Staff Report to the Planning Commission

Application Number: 241360

Applicant: Clay Toombs for Workbench
Owner: Sweet Developments LLC, LHO Santa Cruz Hotel One, L.P.
APN: 025-013-37 & 102-061-10
Site Address: 3500 Paul Sweet Road, Santa Cruz

Project Description: Proposal to construct 105 units within a six-story multifamily building. The project includes a 32.5-percent Density Bonus in exchange for the provision of six affordable units (comprised of six Extremely Low (ELI) units). Requires approval of a Site Development Permit pursuant to SB 330 and Builder's Remedy (Gov. Code § 65589.5) and Density Bonus pursuant to Government Code Section 65915.

Figure 2-20. Heliport Protection Zone (HPZ)

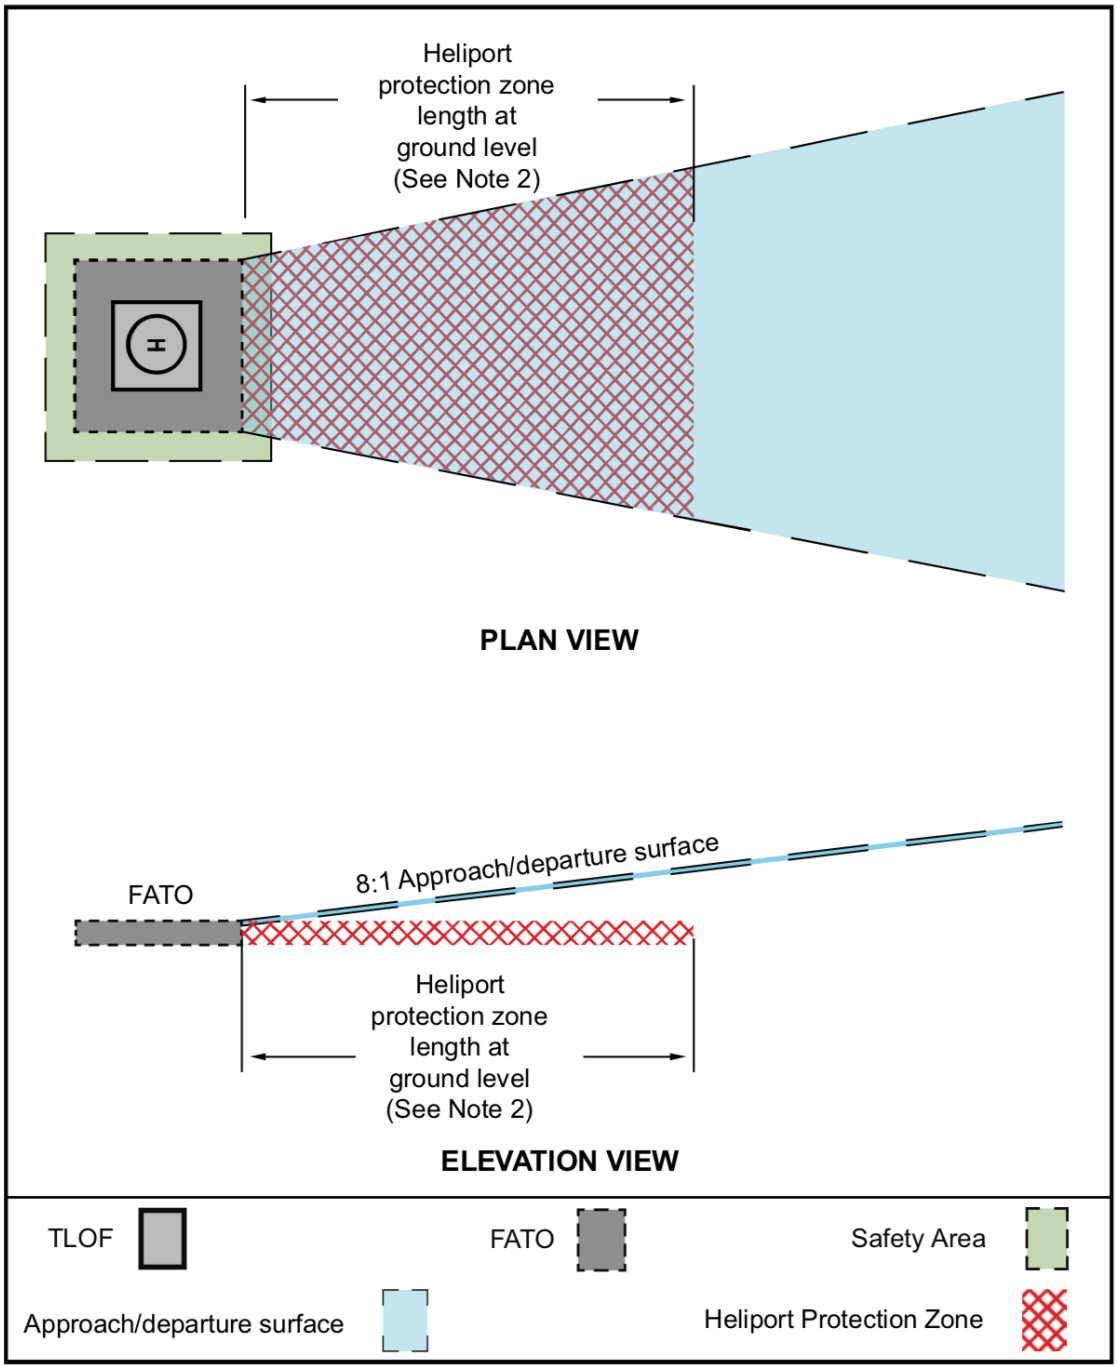
In the above noted email Clay cites Figure 2-20 on Page 2-36 of a publication that shows the Heliport Protection Zone design: https://www.faa.gov/documentLibrary/media/Advisory_Circular/AC_150_5390_2D_Heliports.pdf.

Figure 2-20 (below) is a requirement for the planning, design and construction of heliports achieved through heliport owner control over the HPZ and has nothing to do with the construction of a building near an existing heliport.

Figure 1-4. Offsite Development Requiring Notice to the FAA

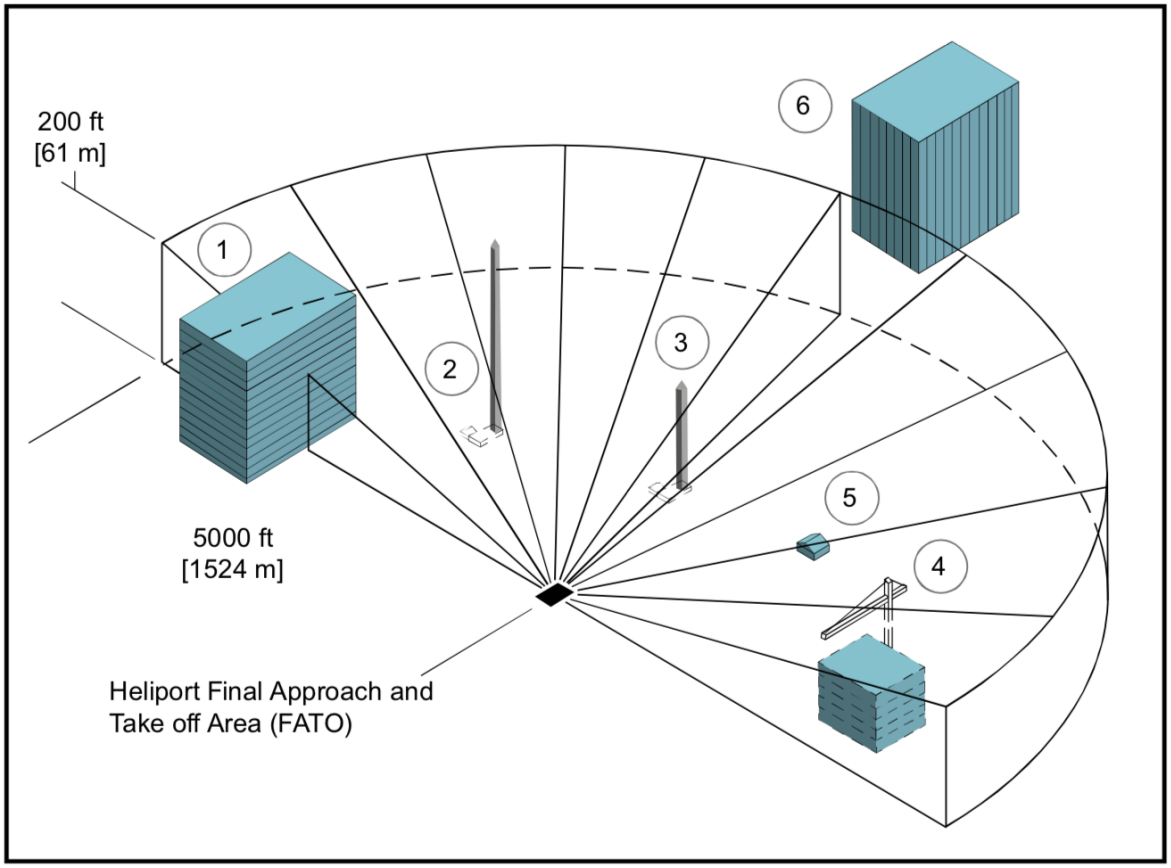
The section of FAA Advisory Circular AC 150/5390-2D that applies to Workbench's project is section 1.11 **Hazards to Air Navigation.** Workbench's 3500 Paul Sweet Road project fits Example 1 of Figure 1-4 (below) and as such requires notice to the FAA. Example 1 is a building less than 200 feet (ft) (61 meters (m)) in height, but top will penetrate the 25:1 surface (notice required by § 77.9).

Figure 1 Public Sewer Connections, Parcels 025-013-34 & 38

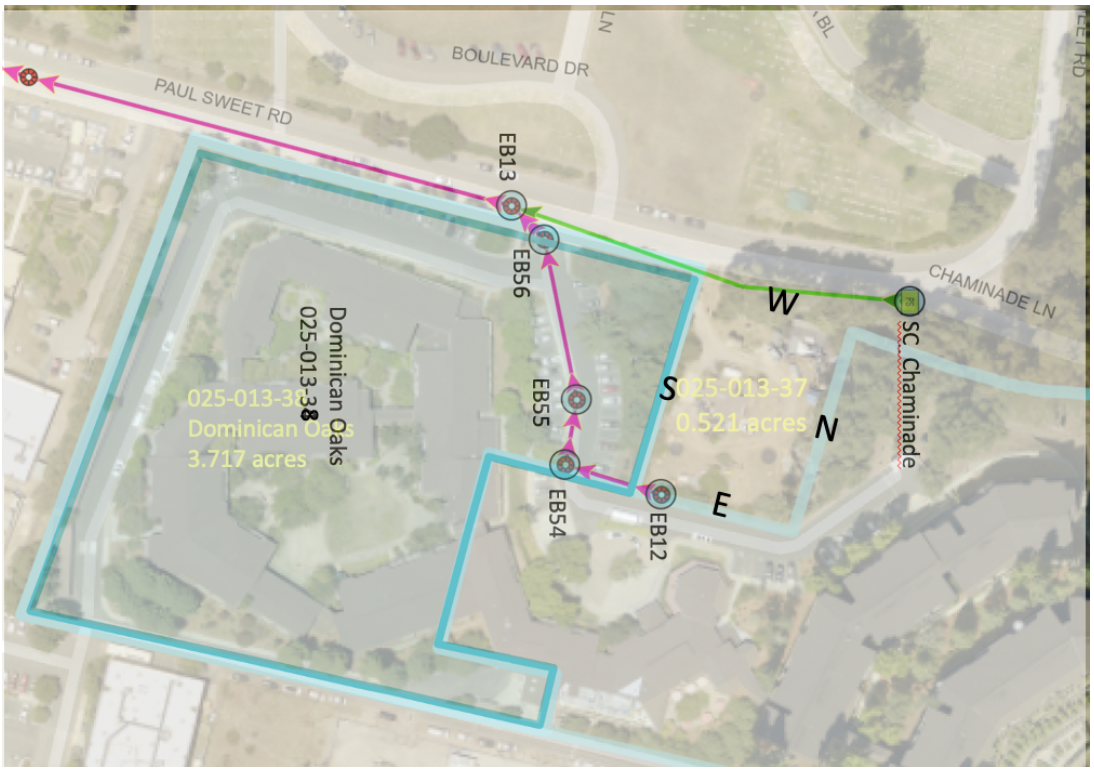
The only observable sewer connection is in the southeast corner of the property and this connection closely matches publicly maintained EB12 (see Figure 1 below).

If the easement is not granted and Workbench moves their structure off of EB12, what will the county access requirements be, i.e. setback amount?
